PROJECT TITLE:
GARDEN HILL FIRST NATION +
WASAGAMACK FIRST NATION
HOUSING PROJECT
STREET NAME AND NUMBER
CITY, PROVINCE, POSTAL CODE

DRAWING TITLE:
FLOOR PLAN

A-1
SHEET 1 OUT OF 06

A-4
 SHEET 4 OUT OF 06

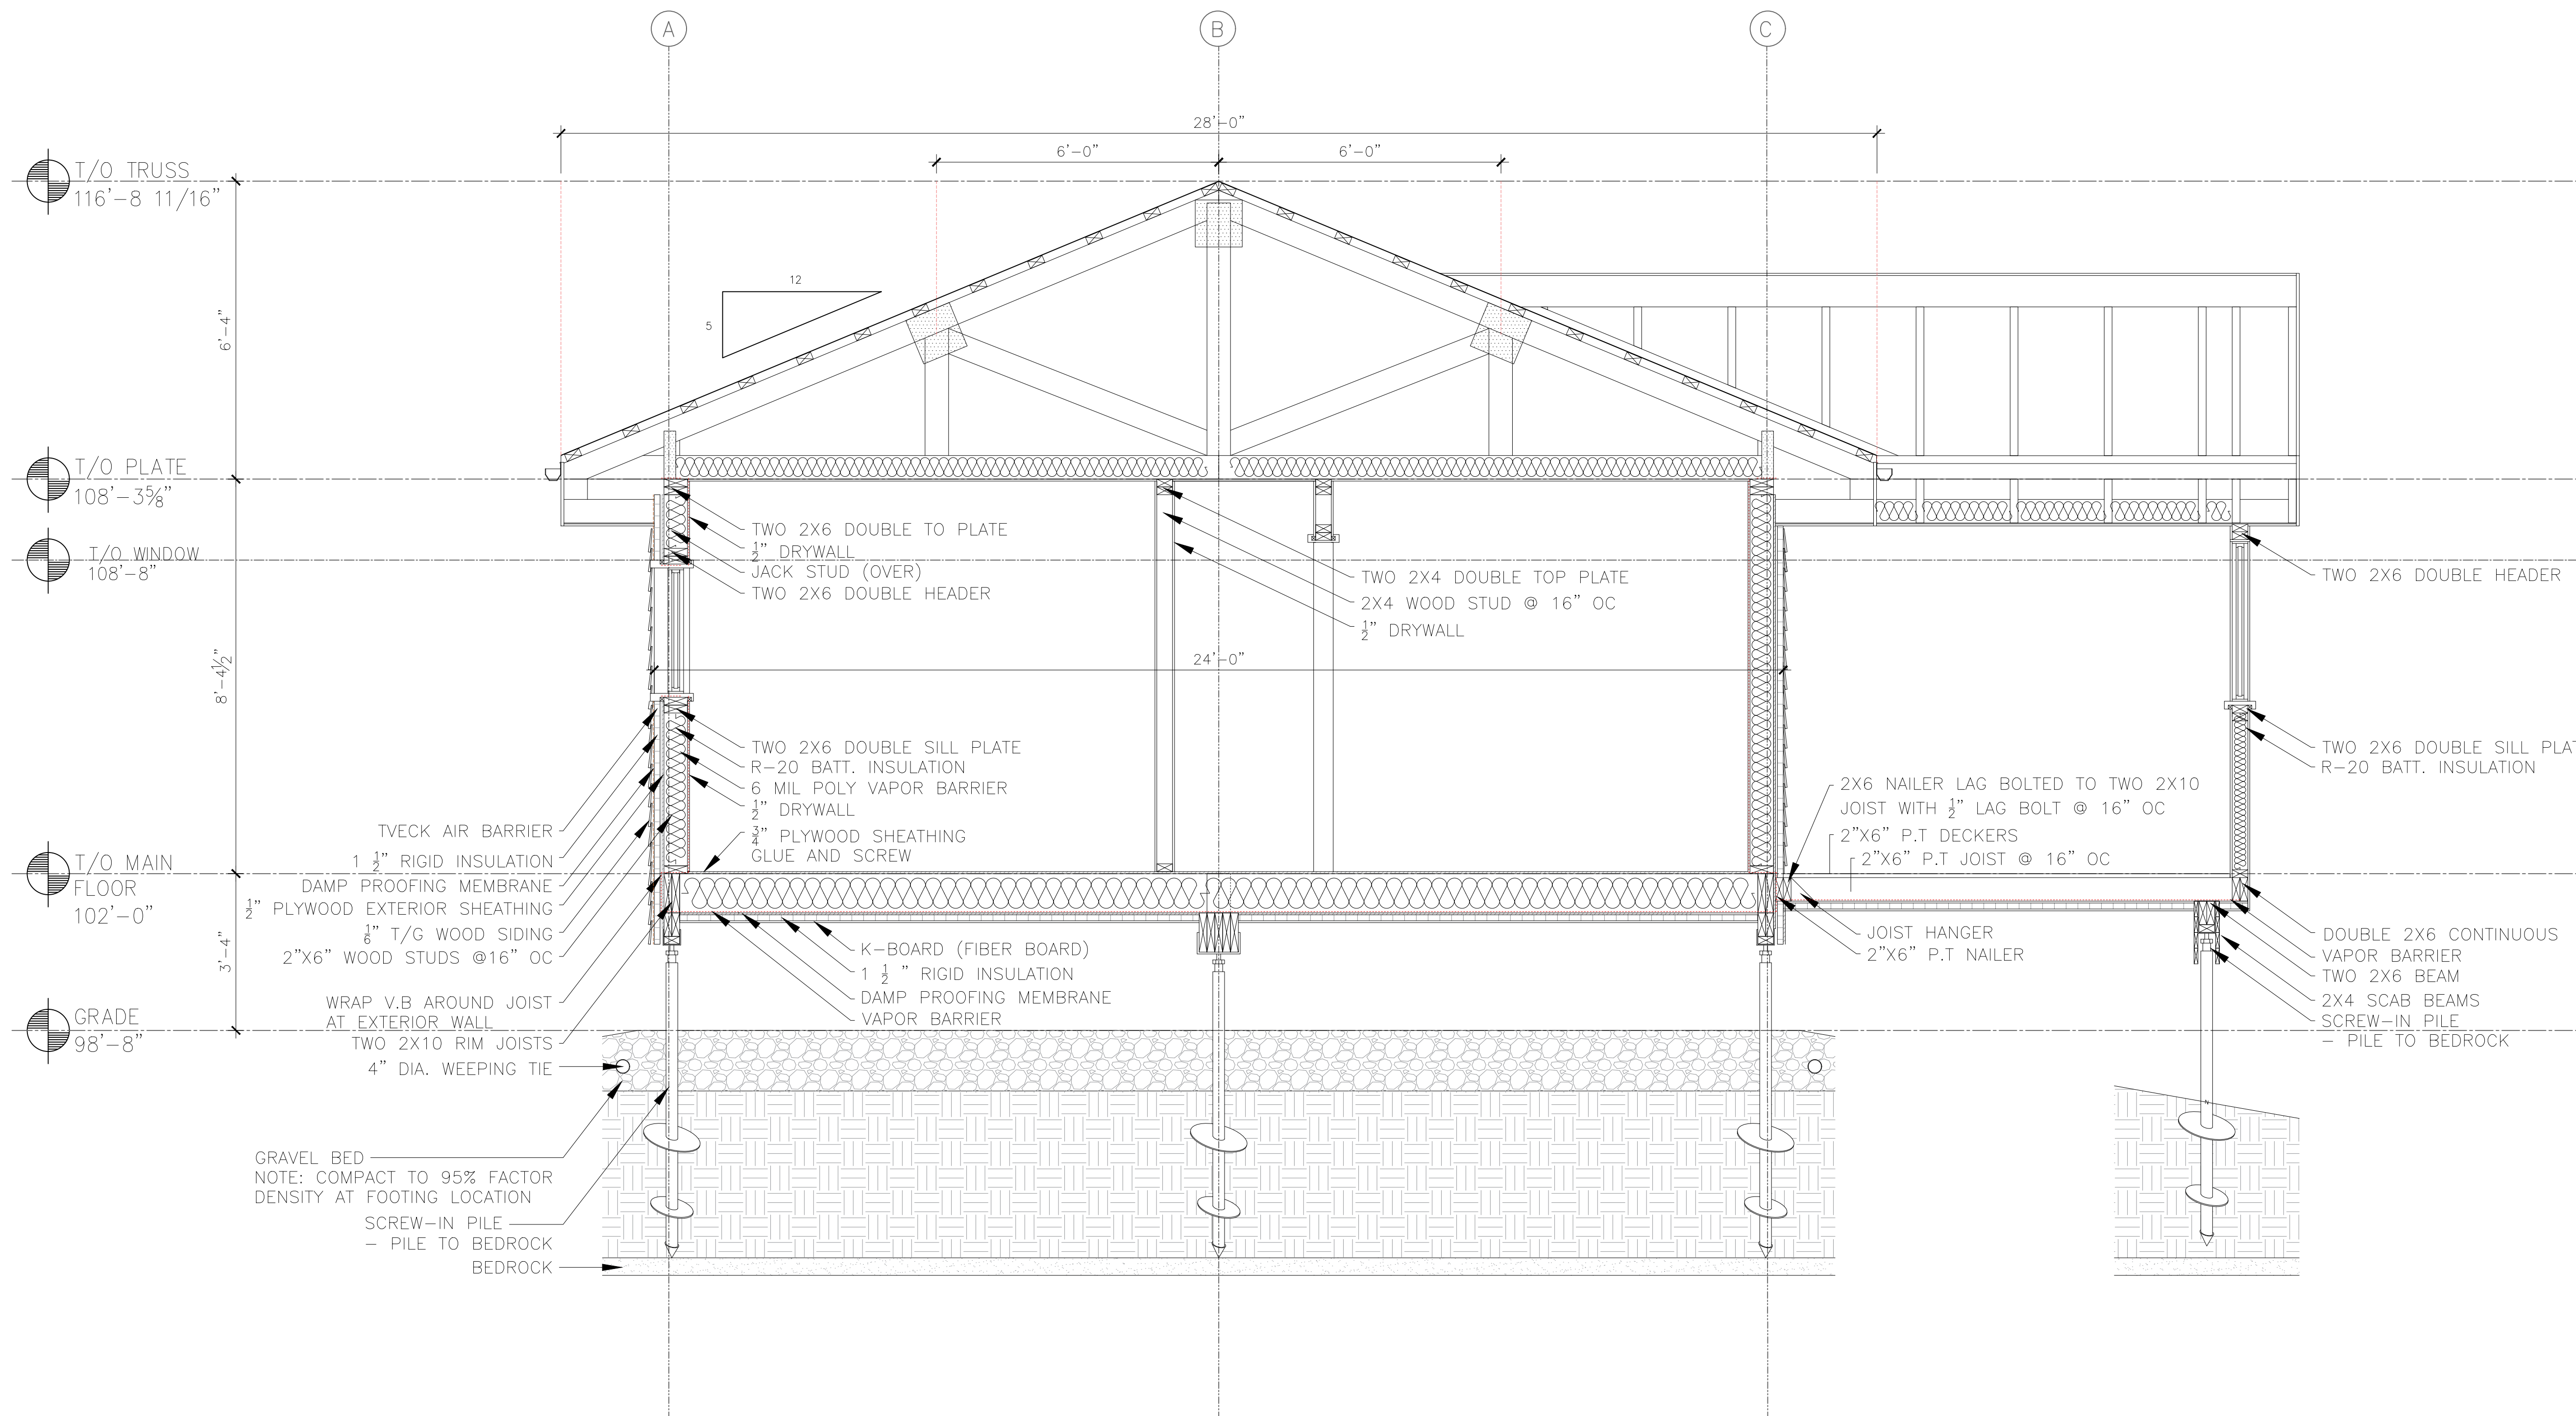
CONCERNS FOR REVIEW:
 1. CONSTRUCTION OF ENCLOSED VERTICAL CHASE
 I.1. ON PACKED GRAVEL?
 I.2. HOW TO INSULATE?
 2. STRUCTURAL LOAD CALCULATION MUST BE DONE. ADJUSTMENTS SHOULD BE MADE.
 3. ROOF AND CEILING ASSEMBLY.
 4. CHIMNEY AND MASONRY INTERIOR WALLS HAVE NOTE BEEN DETAILED.
 4.1. PLEASE TAKE A LOOK AND DETAIL AS APPROPRIATE.

A-5
 SHEET 5 OUT OF 06

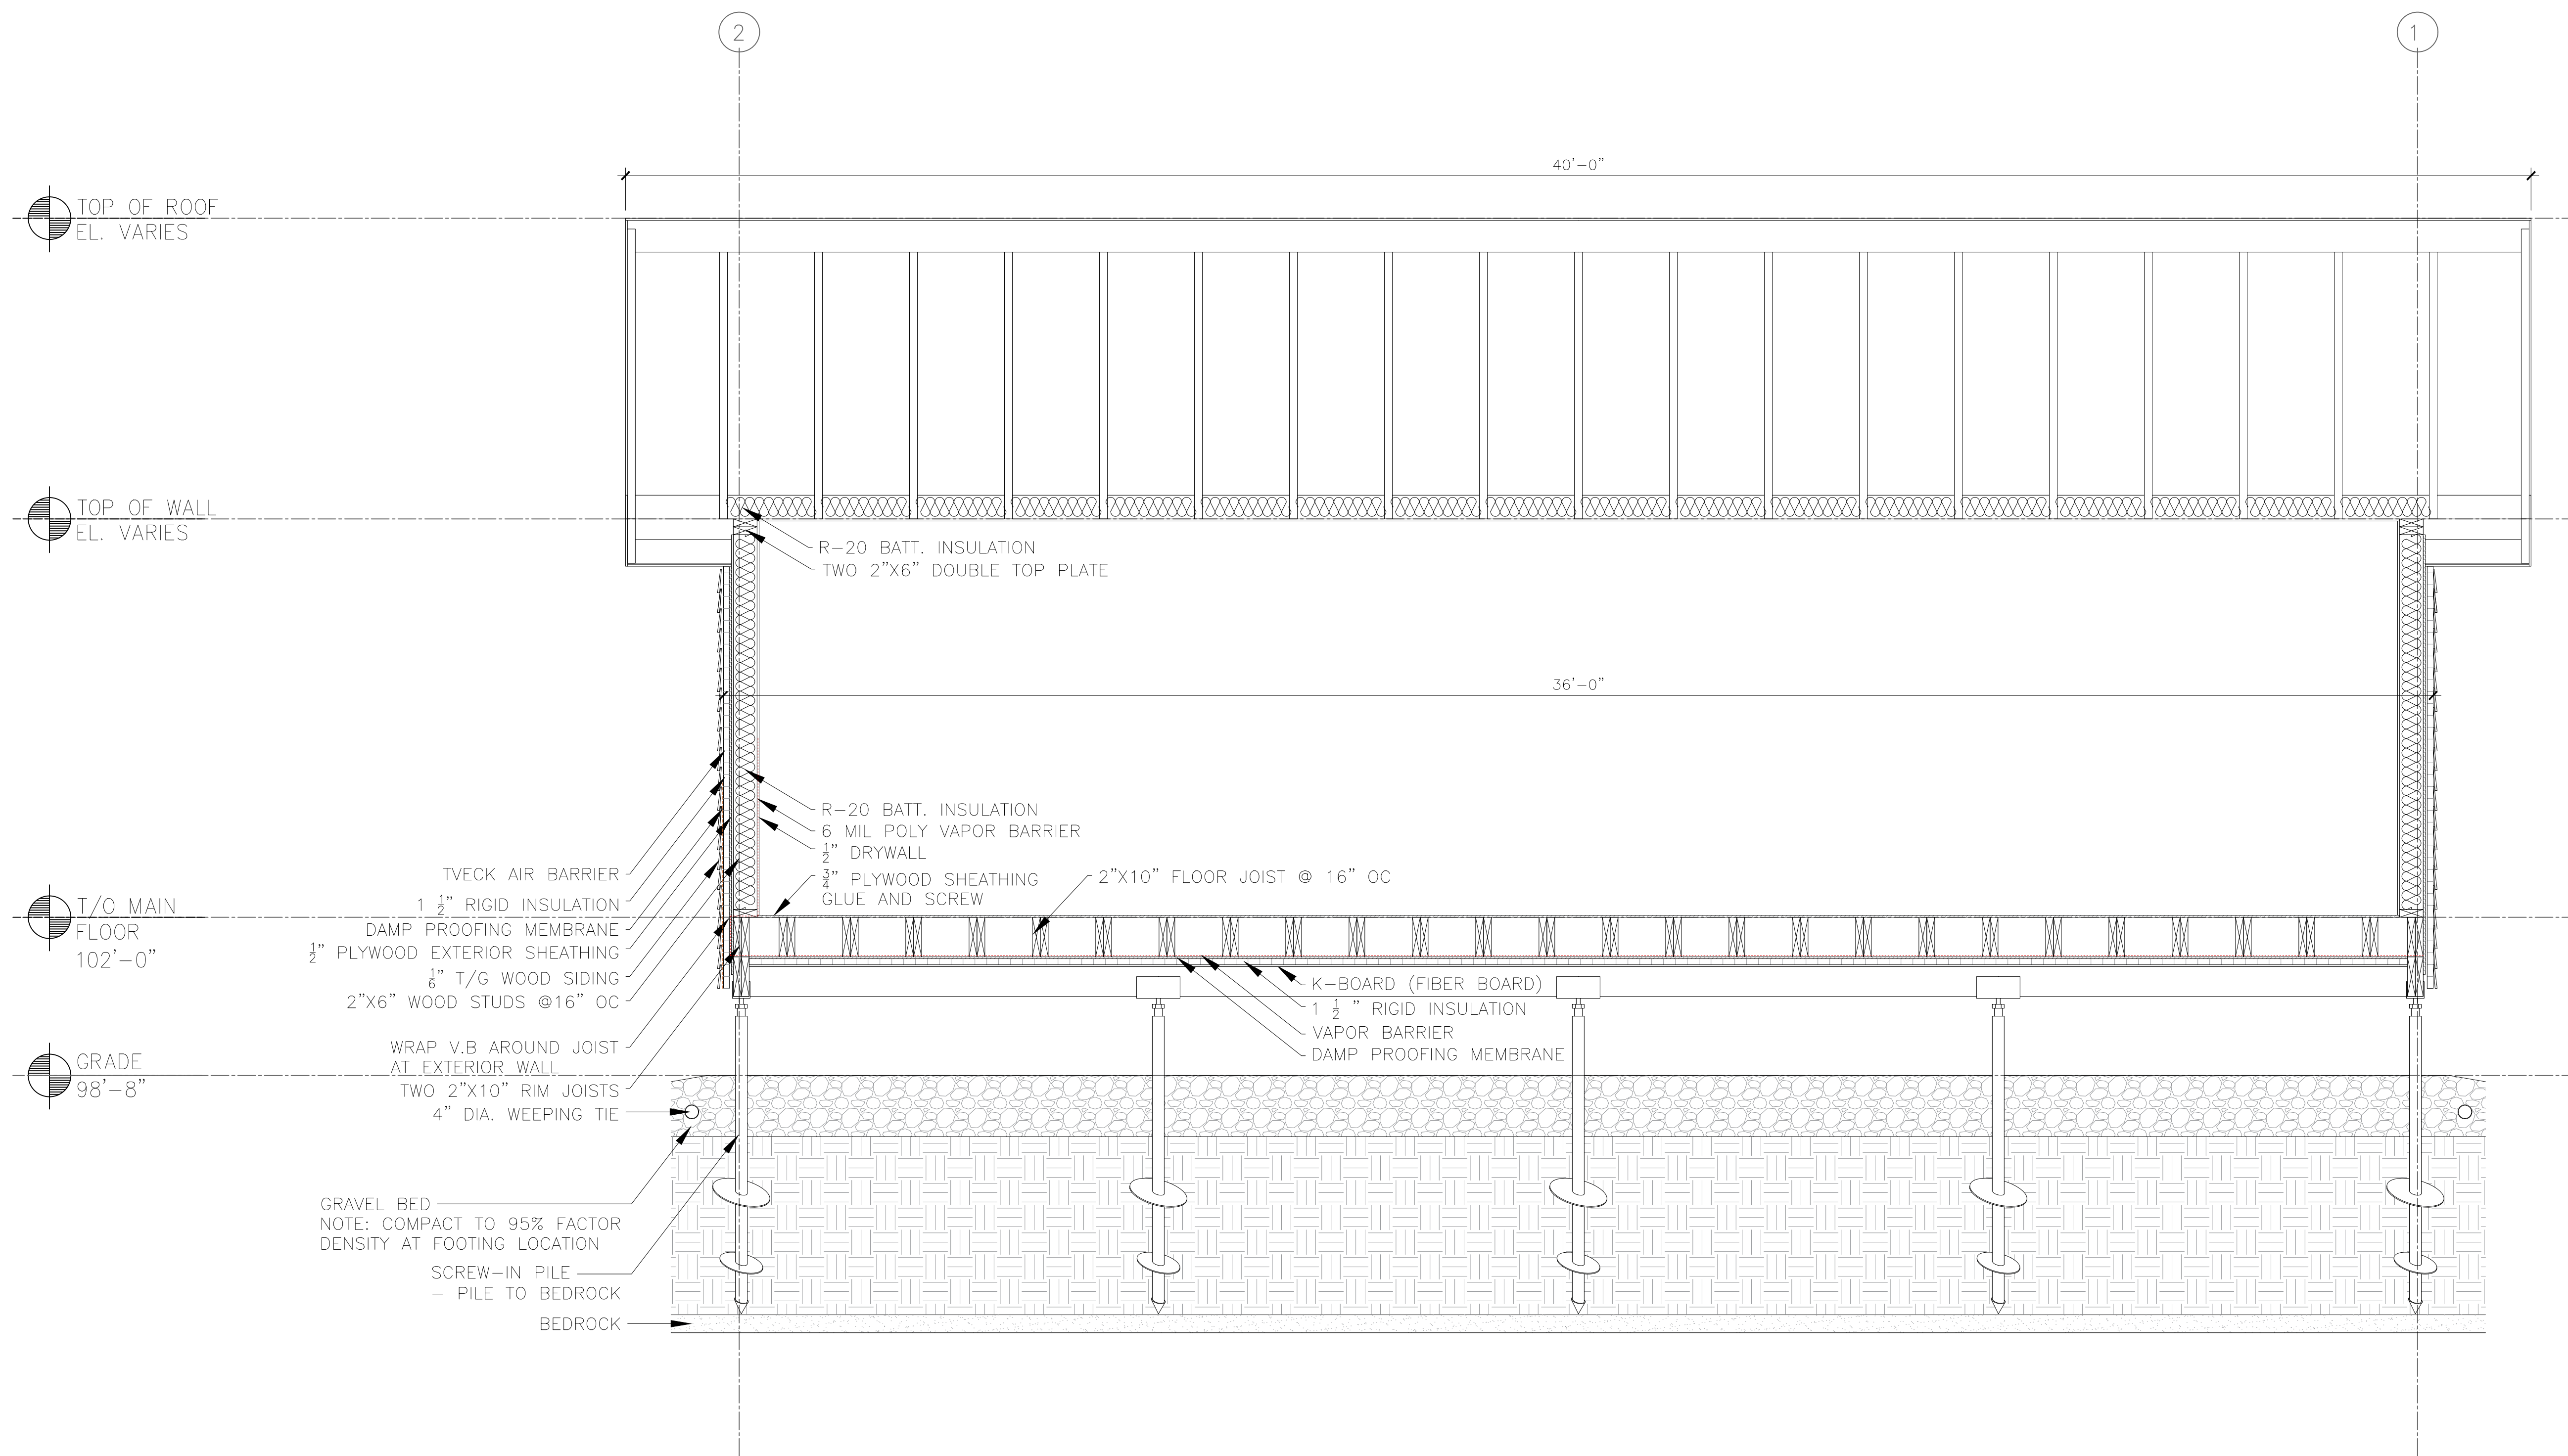
CONCERNS FOR REVIEW:
 1. CONSTRUCTION OF ENCLOSED VERTICAL CHASE
 I.1. ON PACKED GRAVEL?
 I.2. HOW TO INSULATE?
 2. STRUCTURAL LOAD CALCULATION MUST BE DONE. ADJUSTMENTS SHOULD BE MADE.
 3. ROOF AND CEILING ASSEMBLY.
 4. CHIMNEY AND MASONRY INTERIOR WALLS HAVE NOTE BEEN DETAILED.
 4.1. PLEASE TAKE A LOOK AND DETAIL AS APPROPRIATE.
